Subject: RE: NYM/2022/0249 Land Adj Low Farm Beacon Way Sneaton E11107-36 Client
08.06.22

Please see attached the drawings amended following your comments of the 13th May. These drawings are intended to provide information to address your points; 1, 3, 4, 5, 7, 8, 10 and 11.

CLIENT:	Mr Stainthorpe
PROJECT:	Low Farm Sneaton
Drawing:	Scheme one Proposed Block Plan
DRAWING STATUS:	Preliminary
DRAWN:	C Eynon
CHECKED:	N I Duffield
SCALE @ SIZE:	1:200@ A1
DATE:	15/06/17
DRAWING No:	D11107-03
REV:	I

SCALE @ SIZE: **1:50 @ A1** DATE: **01/10/21**

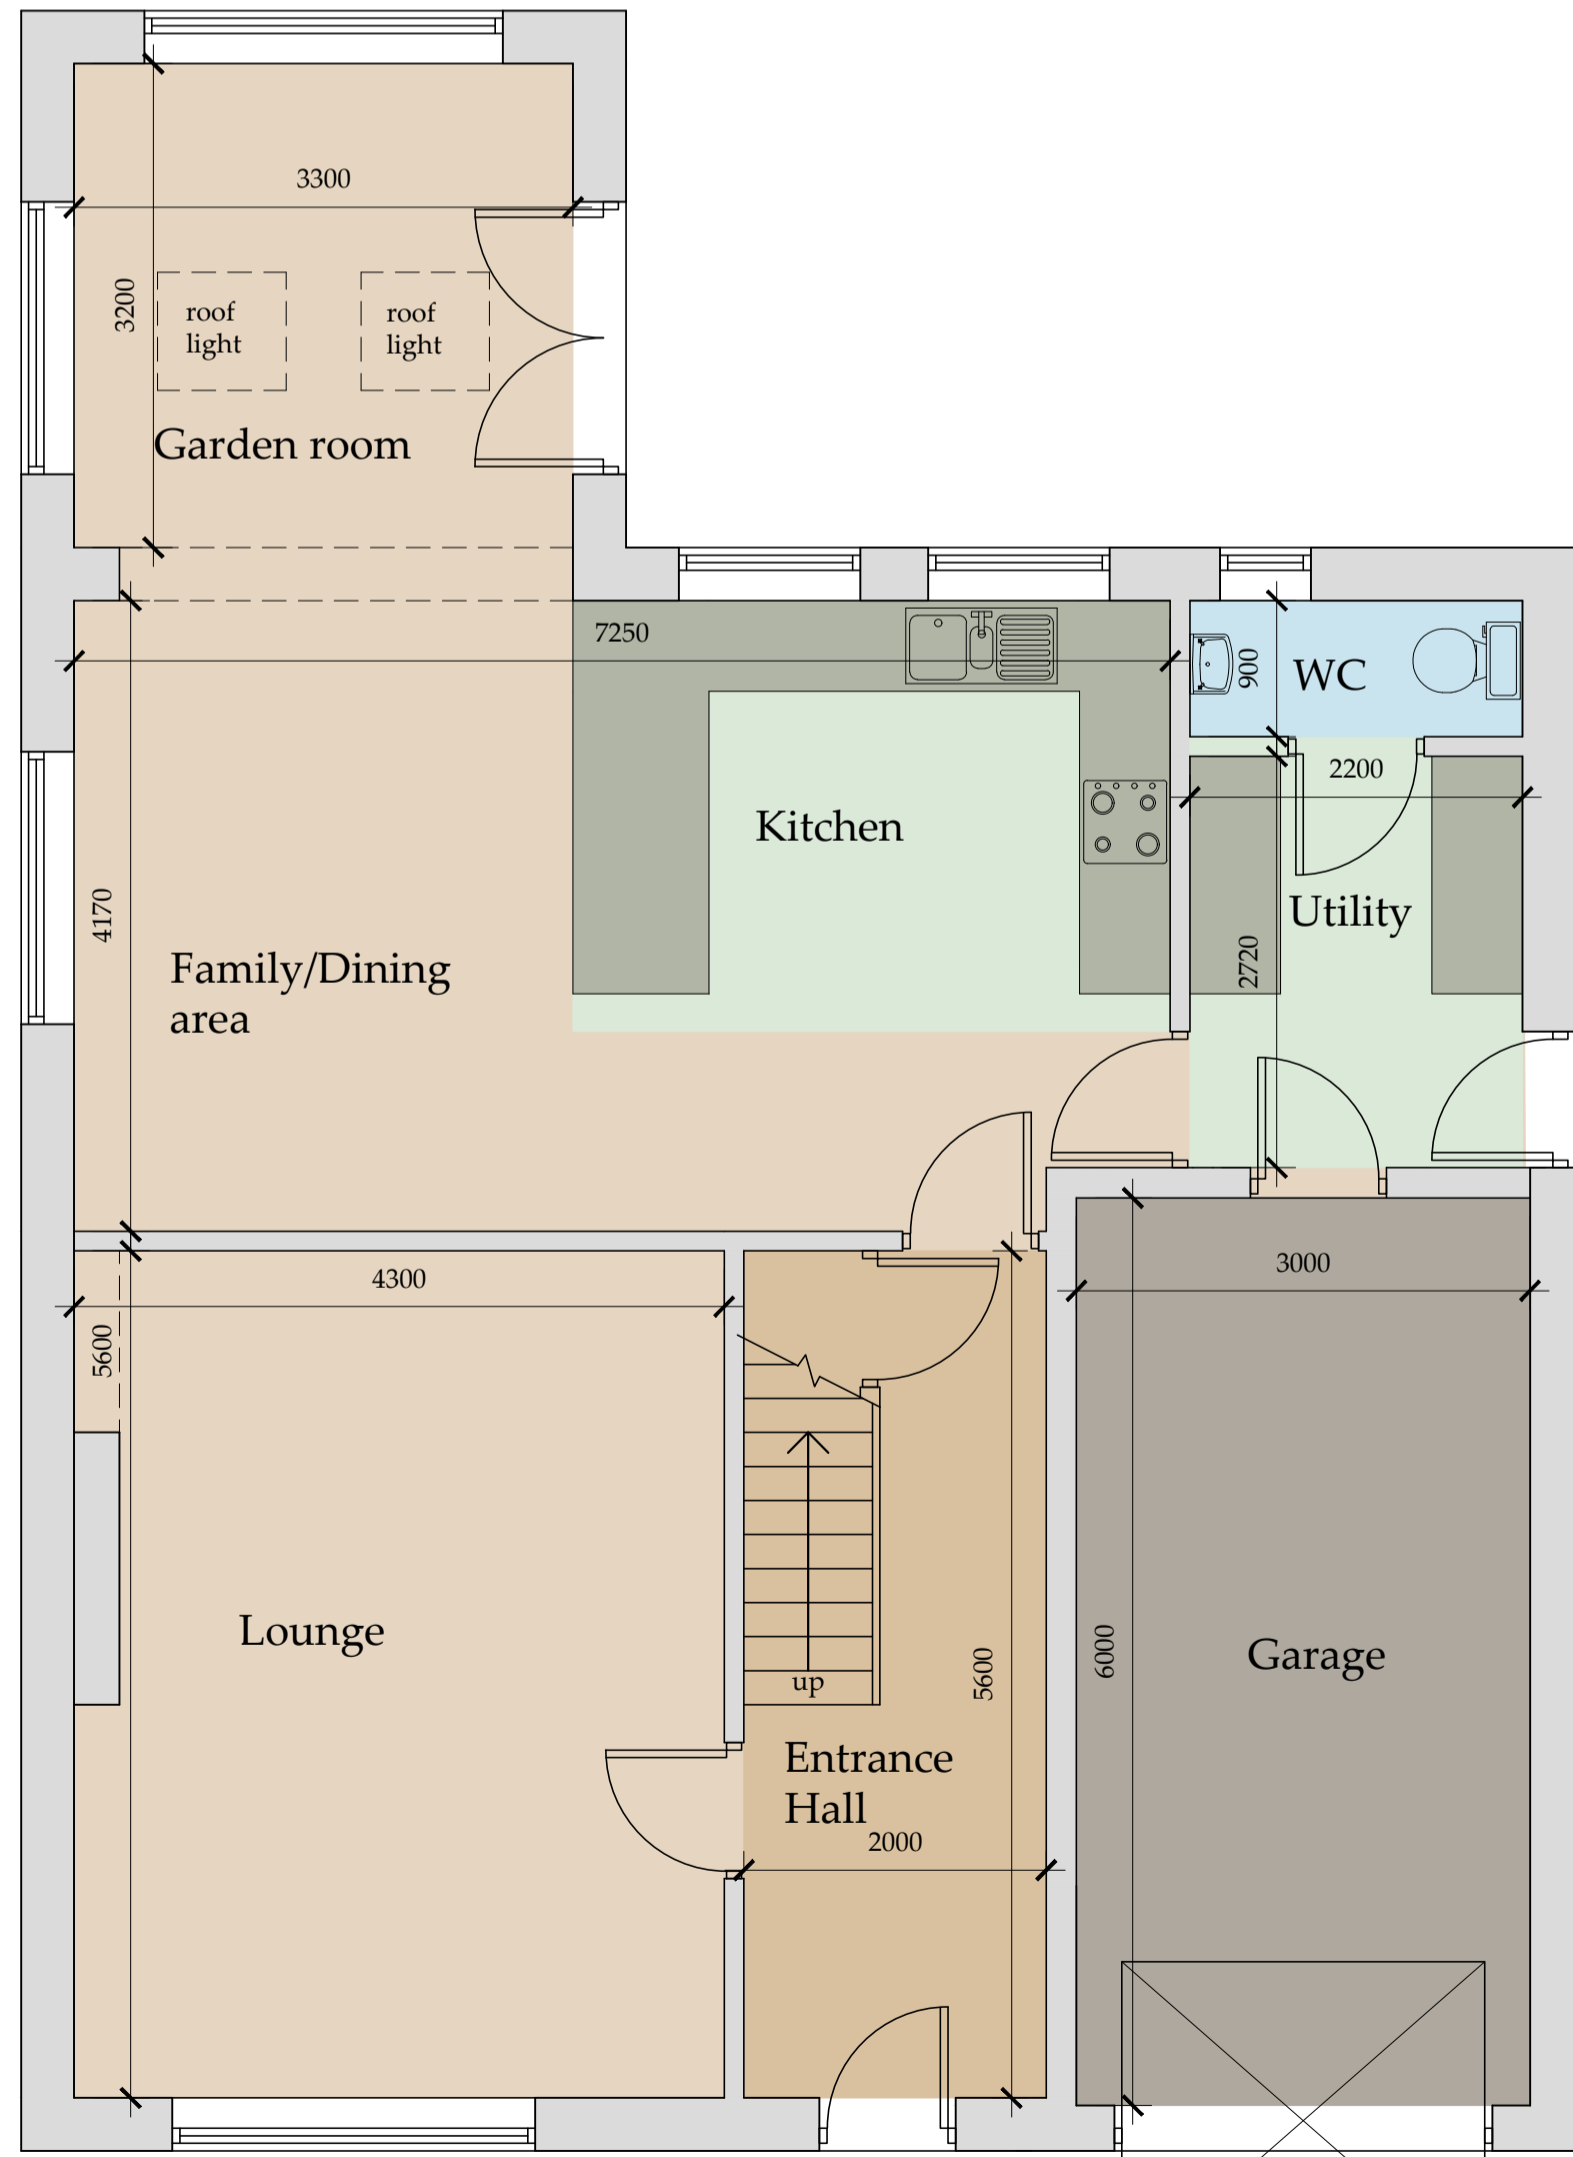
Item 7. Plots 1 and 2; Front elevation extended forward to create single plane façade. We could put a canopy on? Front door sidelight removed. Fanlight added. Minor changes made to 1st Floor layout. They could benefit from some other internal changes but these can be carried out after the planning decision.

Item 7- As previous email .The projecting porch and garages to the detached units have been removed as requested, see drawings.

CLIENT:	Mr Stainthorpe
PROJECT:	Low Farm Sneaton
Drawing:	Proposed Plans and Elevations
DRAWING STATUS:	Preliminary
DRAWN:	C Eynon
CHECKED:	
SCALE @ SIZE:	1:100@ A1
DATE:	11/09/17
DRAWING No:	D11107-11
REV:	E

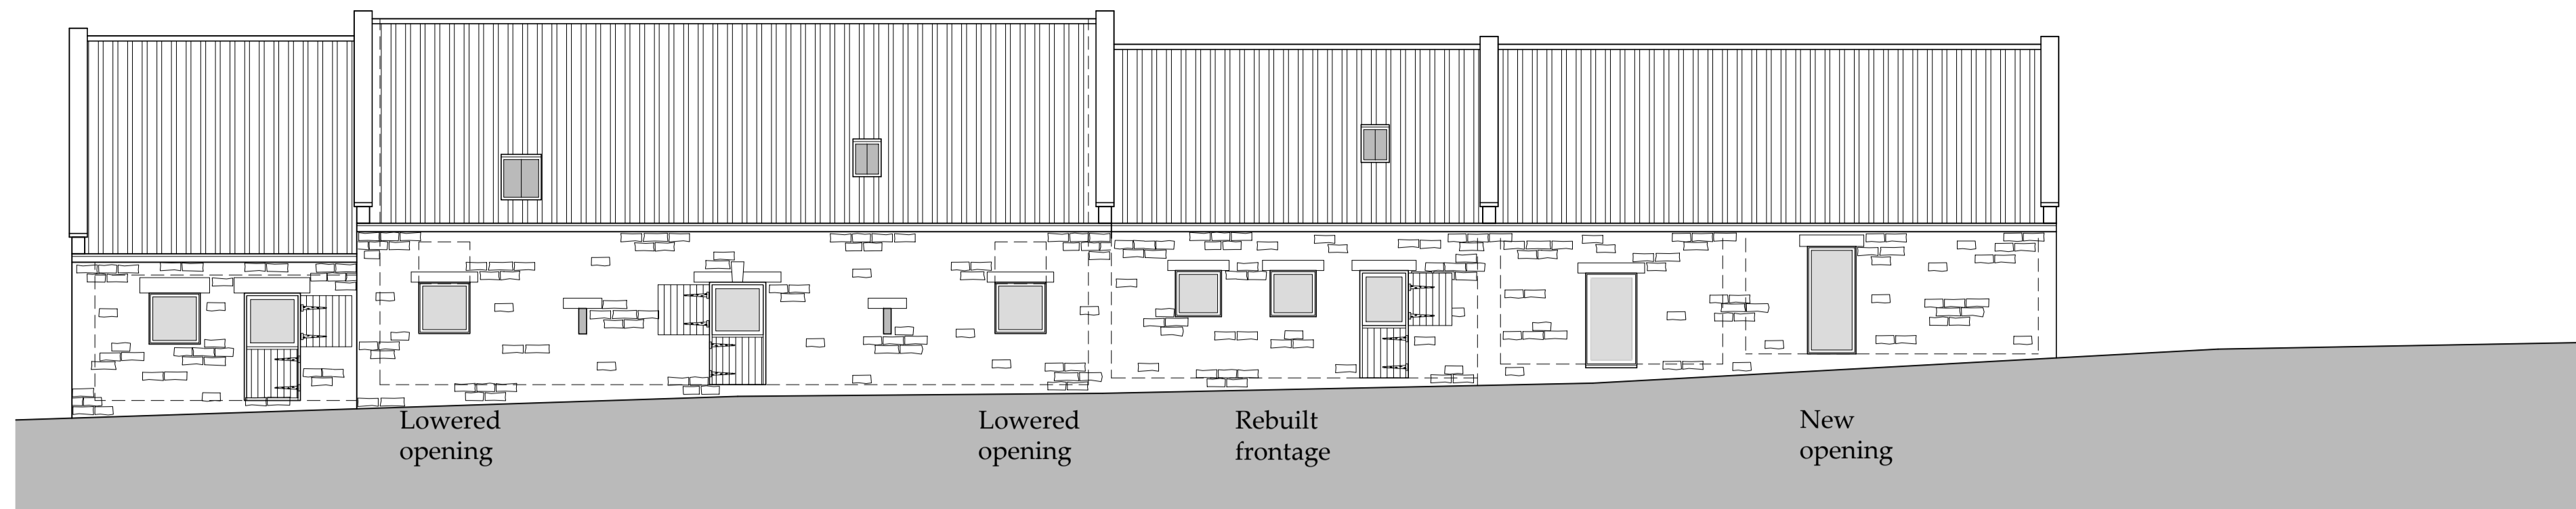
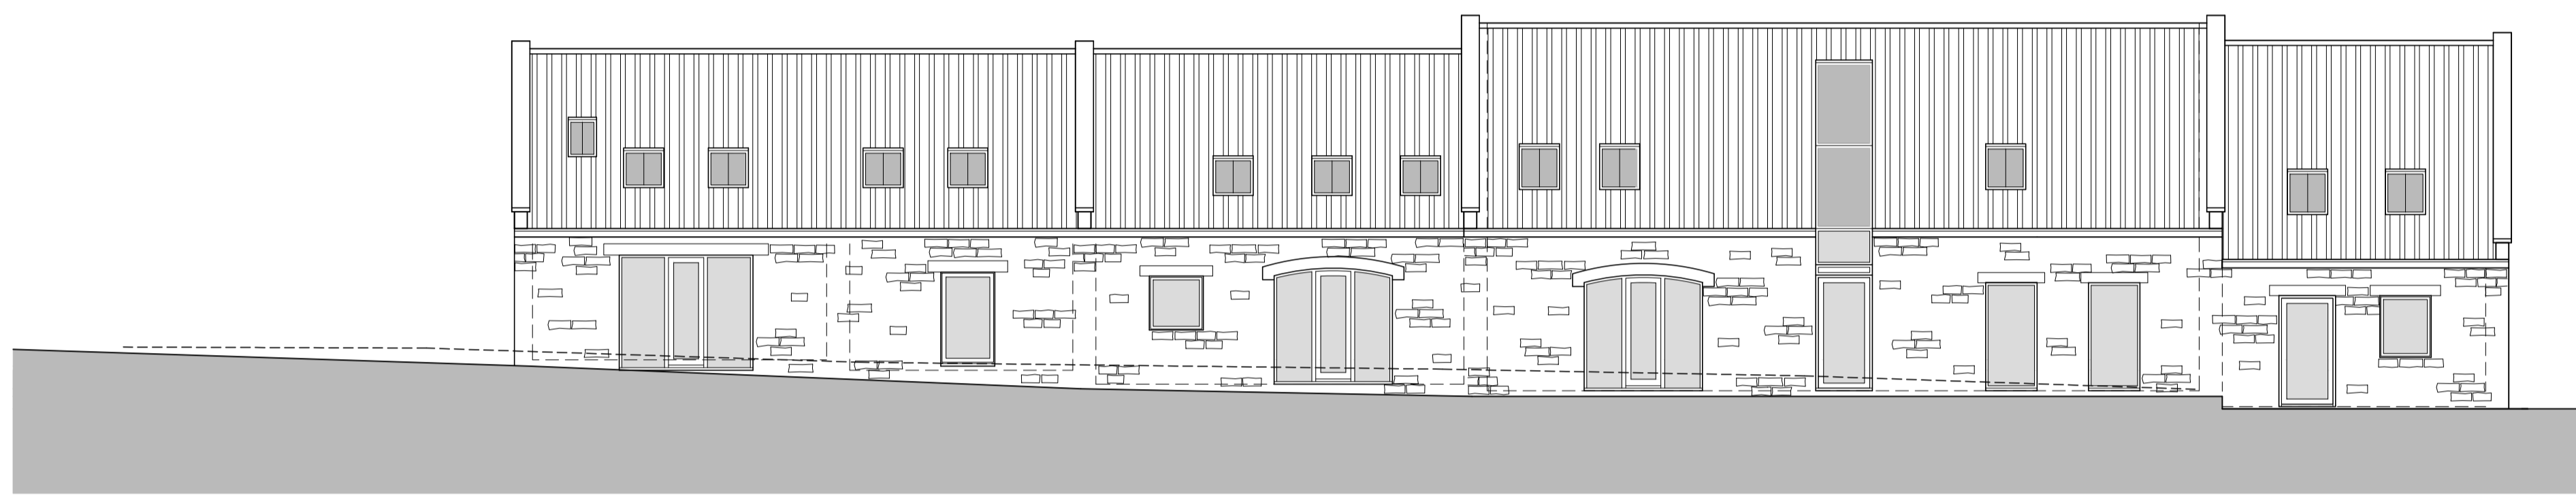
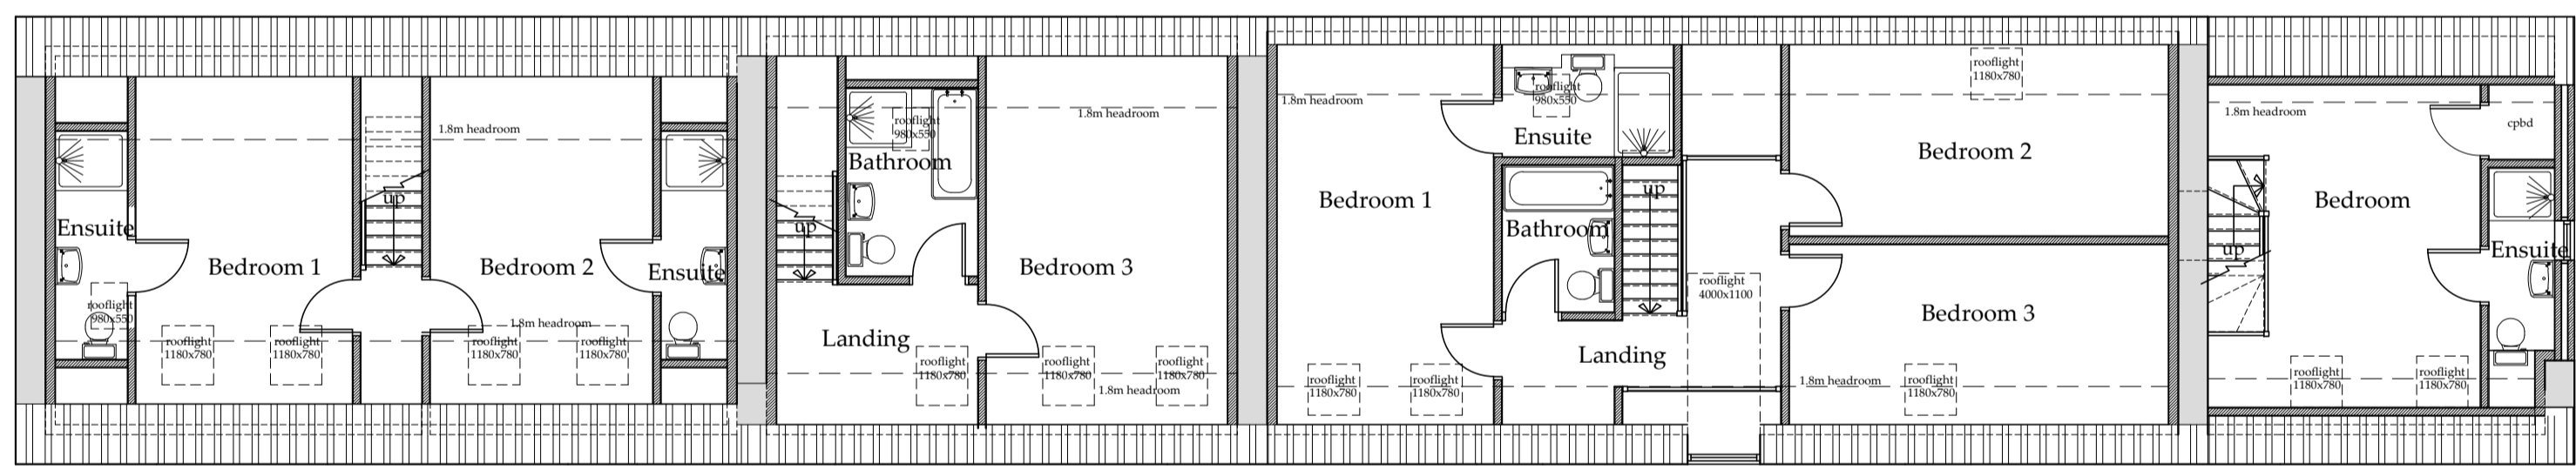
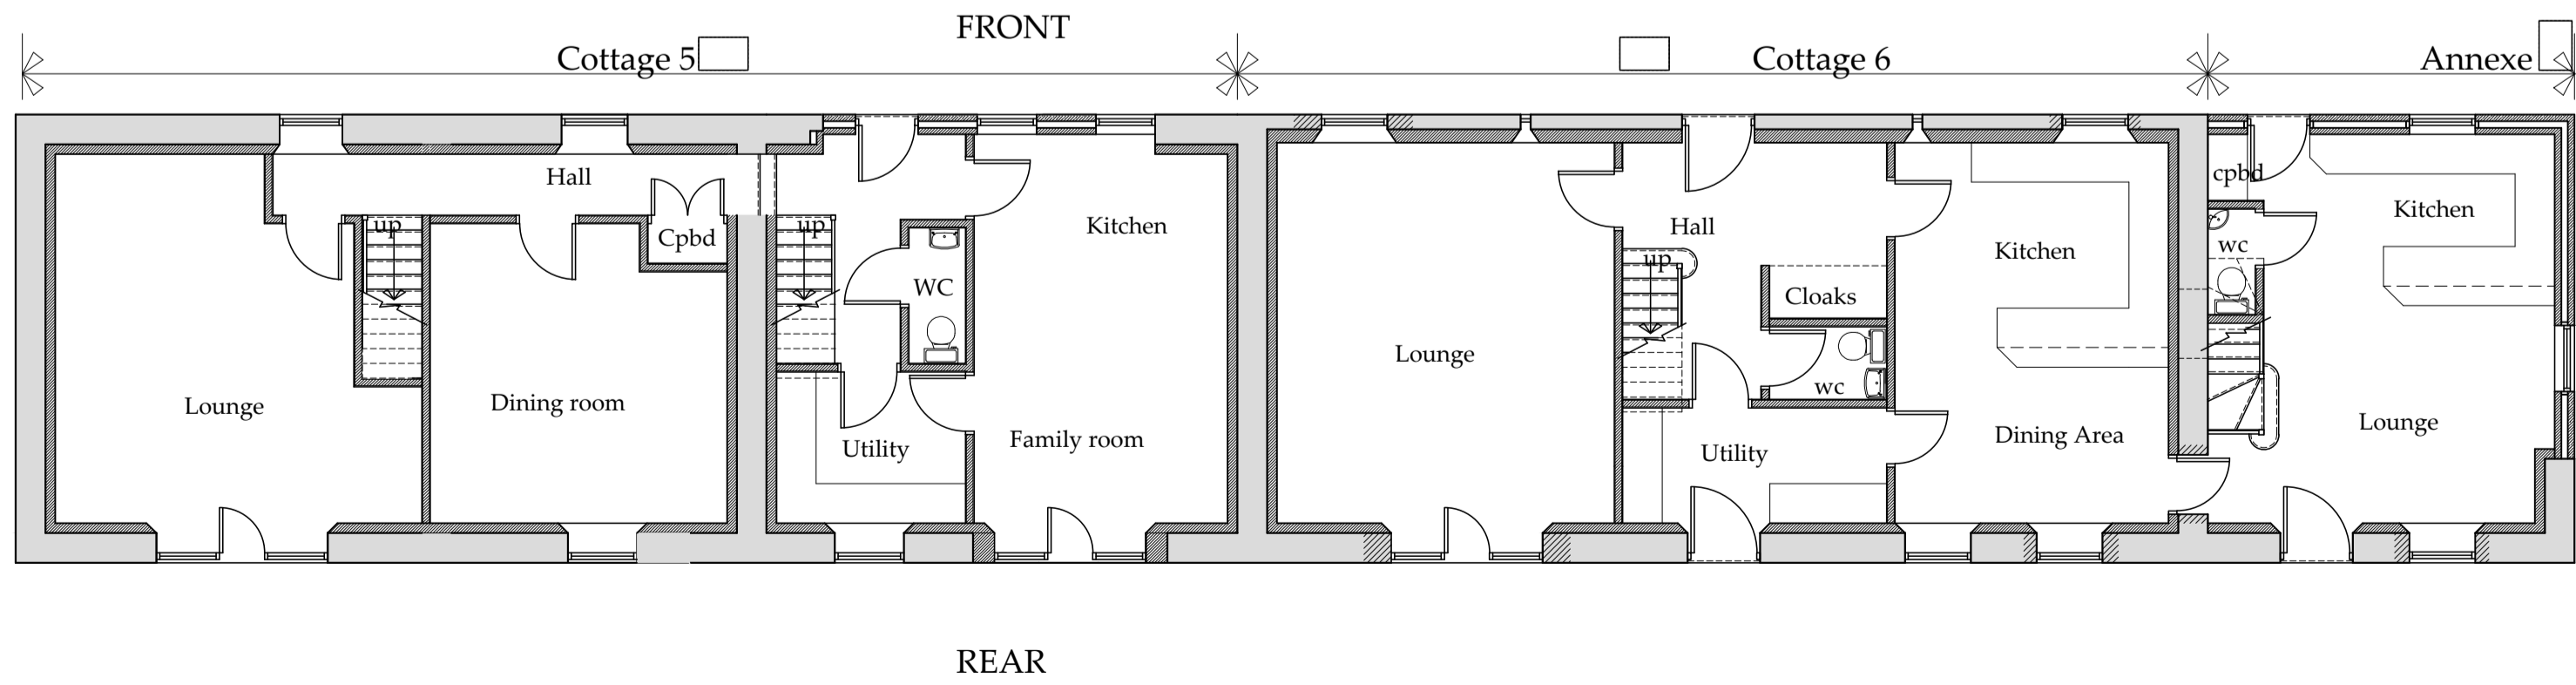
Items 8 and 10, Conversions; Rooflights reduced to a minimum with as many as possible removed from the front elevation, 3 only remaining. These present a modest and non uniform appearance. An internal link to the Annexe has been shown, it is to be tied to Cottage 6.

Item 8- As previous email, also The proposed design in respect of the barn conversions has been amended considerably in this respect. There has been a significant reduction in the number of roof lights proposed to the front elevation which has made a significant impact to the overall aesthetic. Although this is not a full removal, where roof lights have been retained, they are essential for the function and uses internally to make the conversions feasible with adequate light levels and appropriate means of escape.

Item 10- The part of the conversion referred to as an annex to cottage 6 is to have an internal link door. Plans amended to show this. This will be completely tied to unit 6 and it is not proposed in any way that this be sold separately. Full acceptance of a condition to reflect.
